ENGINEERING PRACTICE STUDY

TITLE: PARAMETERS TO BE MEASURED DURING BOARD FLEX TESTING FOR
MULTILAYER CERAMIC CAPACITORS (MLCCs)

Project Number: 5910-2024-021

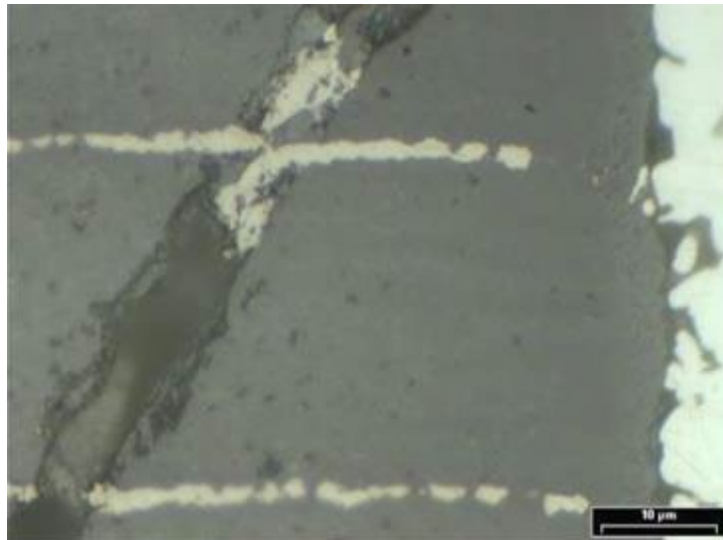
I'm not sure if manufacturers can actually monitor IR and Capacitance at the same time during testing. They can chime in on that. I looked at the [AEC-Q200-005](#) board flex test method and it specifies the measurement requirement below. The example is a megohmmeter which would be similar to monitoring IR. I'm not sure that the resistance will always decrease though. If the termination cracks or even a major ceramic crack, the bending force will pull the two halves apart potentially decreasing the resistance. I'm fine in general adding IR as a monitored electrical during test, but we would likely need a plus and minus percentage of allowed change. The manufacturers may need to do some testing to establish that limit.

[AEC-Q200-005](#) para 3.3: Prior to beam load testing, complete the external Visual test in Q200. A test monitor shall be used to detect when a part cracks or a termination failure occurs. (example: Megohmmeter attached with leads during the time the force is being applied to a ceramic capacitor. A crack would cause a deflection of the needle towards zero.)
